# Queenstown Gardens Safety Report

Produced for Queenstown Lakes District Council

Date: 23/08/2017  
Reference: 6-XQ066.02  
Status: for Release

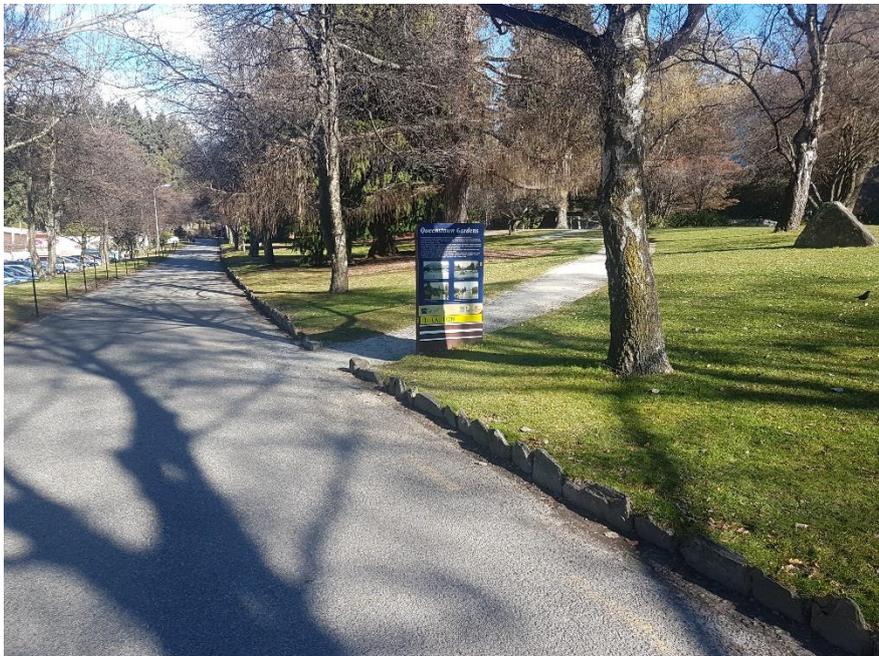
#### 4.1.1. Narrow Entry

The current vehicle entry is 3.5 to 4m wide. This is not adequate to allow for two-directional traffic. As such vehicles perform unorthodox movements and inappropriately give-way to exiting vehicles in order to enter.

In order to improve user safety, the current vehicle entrance should be widened to accommodate vehicles moving past each other.

**4.4. Tennis Club, Bowls Club, & Maintenance Lot Access and Parking Significant**

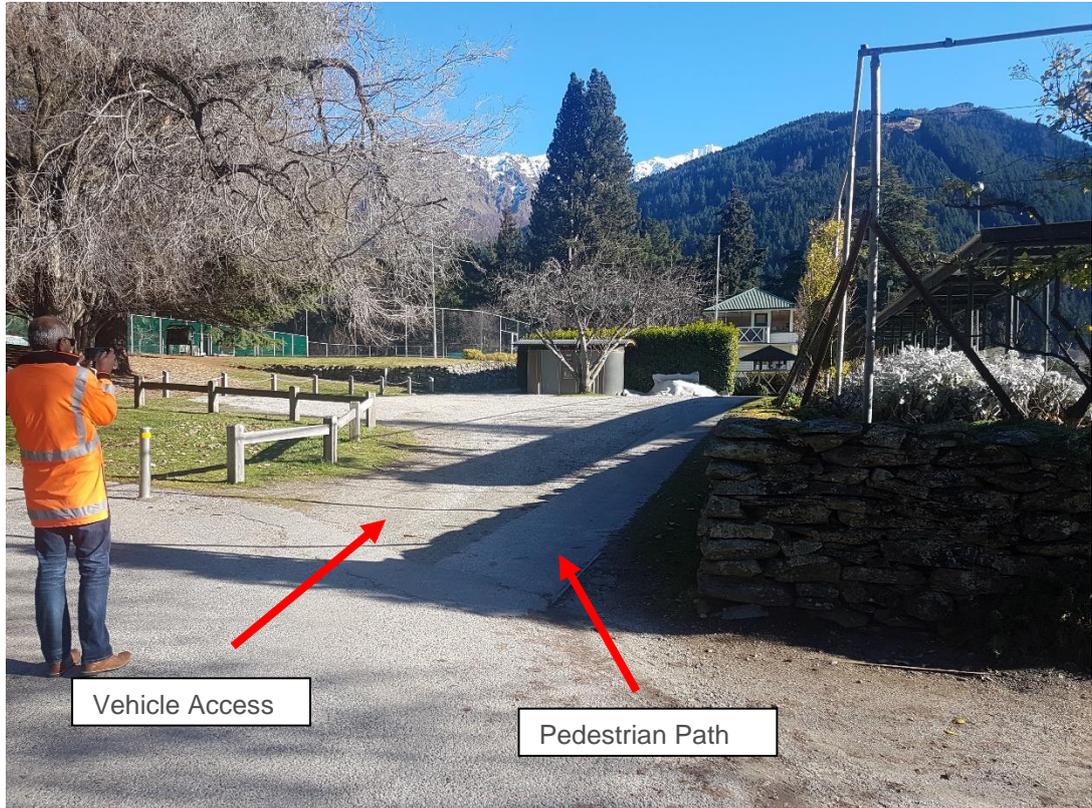
Access and parking for the maintenance lot, tennis and bowls clubs is located at the western end of the main garden driveway. There is also a public toilet located in the tennis club carpark. Similar to the driveway, there is often a mix of vehicles and pedestrians. Collisions are expected to occur occasionally, however serious injury is likely to result due to vehicle – pedestrian collision.

There is currently several footpaths directly connected to the carparks. Several of these lead into trafficable areas in ways which are not conducive to adequate sight distances, and could result in Pedestrian-vehicle interactions.

Pedestrian crossing points are also not marked clearly, and vehicles/pedestrians may be unaware of the potential for interaction. This may result in users not being as cautious as they need to be at a crossing point.

The parking/no parking areas are not clearly labelled, resulting in parking patterns which are not consistent, and not in a controlled order to maximise safety. As such vehicles were observed parking at un-usual angles and in places which could cause visibility issue for vehicles and pedestrians.

The access way into the maintenance lot is not wide enough for two-way traffic. This may result in vehicles waiting on the main gardens driveway in order to allow vehicles to exit before being able to enter. This is not likely to cause major issues given the low volume of traffic expected to use this access way.

The parking areas and alignment should be marked clearly to ensure parking is occurring in a safe, efficient manner.

Pedestrian areas should be clearly marked as such, and possibly delineated with flexible plastic bollards or similar. This will allow clearer zoning so pedestrians and vehicles have a better idea of where to look out for other users.

In order for this to occur the several small parking zones should become one large parking area, with pedestrian access around the outside.

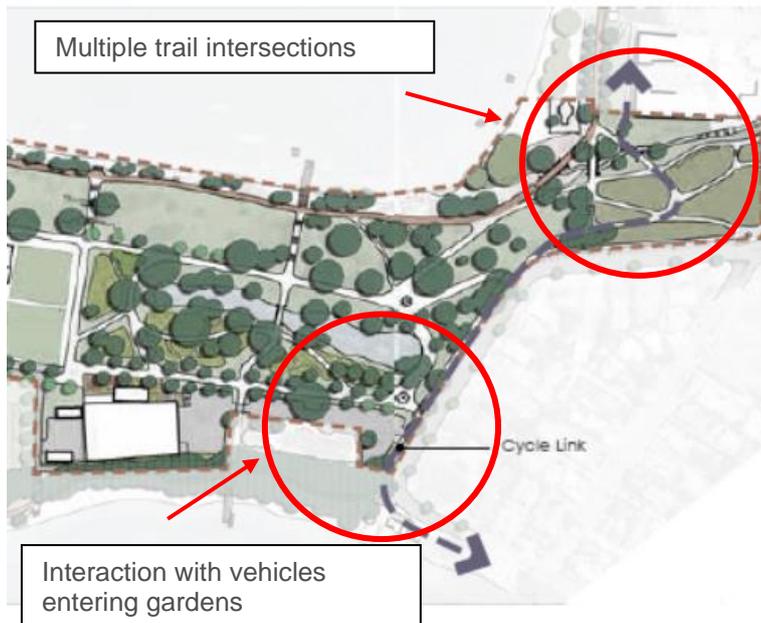
The current paths already present a safety hazard, and are not suitable to cater for an increased traffic load.

The cycle link is indicated to cross the proposed vehicle entrance to the gardens. This is a serious safety concern and it is imperative that any such junctions are designed with safety in mind. The safety of Vehicle/Cyclist intersections can be improved significantly with careful design.

Also of concern is the Northern area of the cycle path where multiple trail junctions occur on a steep hill. These are likely to lead to collisions as users are expected to be travelling very quickly in the Northbound direction.

The additional bridge may provide a bottle neck for users, and should be designed to adequately allow bi-directional traffic to flow without significant restriction.

It is unclear if the cycle link will be available to pedestrian use. The width of the path should be designed to reflect the intended use, and markings & signs must be adequate to inform users in order to prevent dangerous Cyclist – Pedestrian interactions.

The current cycle path along Park Street is not suitable. It is recommended a suitable cycle path be constructed inside the Queenstown gardens boundary, away from the road.

The northern area with several trail intersections should be revised to have less intersections, with those remaining being carefully designed with user safety in mind.

In order to deter pedestrians from using the cycle commuter path, it may be possible to eliminate the pedestrian link to Queenstown Beach.

Care should also be taken to design the proposed bridge with user safety being a high priority.
